SIB 52 01 23

RECALL 23V-039: SIDE AIR BAG COVER (REAR SEATS)

This Service Information Bulletin (Revision 3) replaces SI B52 01 23 **dated February 2023**.

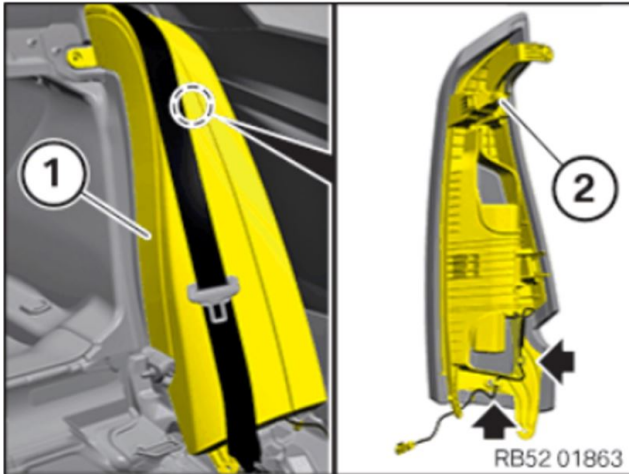
Supplier backrest side panel material does not meet design criteria.

Replace the rear seat backrest side panels (left and right; circled) in accordance with repair instructions 52 26 008 (backrest side panel at the rear seat back).

Unclip and remove the backrest side panel section (1) on the rear seat backrest from the clamp (2).

Check the clamp (2) for damage. A replacement clamp should be present on the new part.

Replace both rear seat backrest side panels which contain the air bag.
